Compliance Inspection Report for Stormwater Discharges from Construction Activities (CGP)

Site/Project Name: Insurance Auto Auctions-Millington	NPDES Tracking Number: TNR155426	Date Coverage was Issued: 8/4/2023
--	---	---

Inspection Purpose: CGP compliance inspection

Photograph 15. View, facing southwest, of sediment accumulation against the silt fence along the Site's southern boundary. Sediment had accumulated to at least half the height of the silt fence.

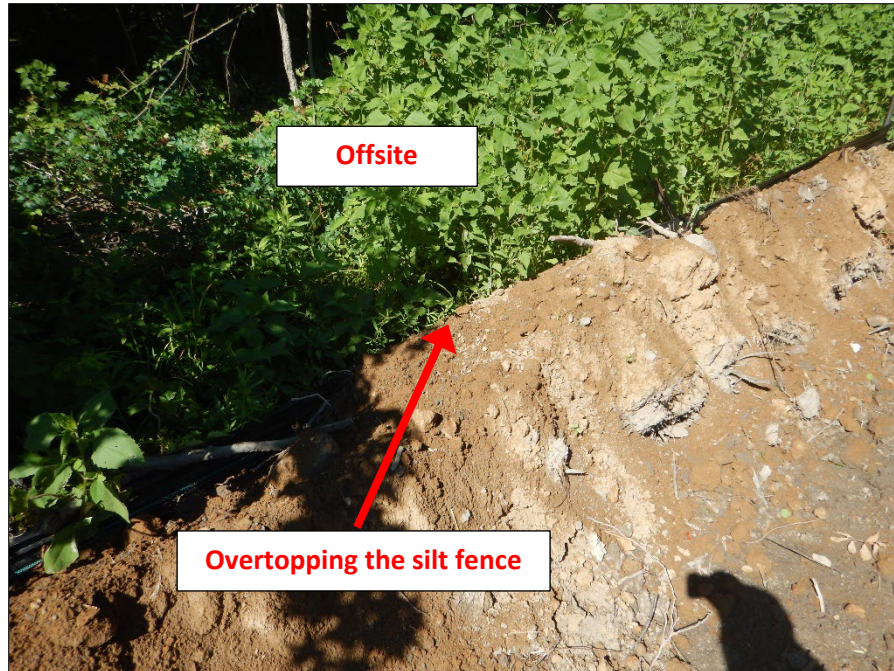
The EPA Inspection Team observed silt fence with sediment accumulation that reduced the capacity of the control by at least 50% [Refer to **Appendix B, Photograph Log (Photographs 15-17, 19-22, and 25)**] [Refer to **Appendix C, Exhibit Log (Exhibit 2)**].
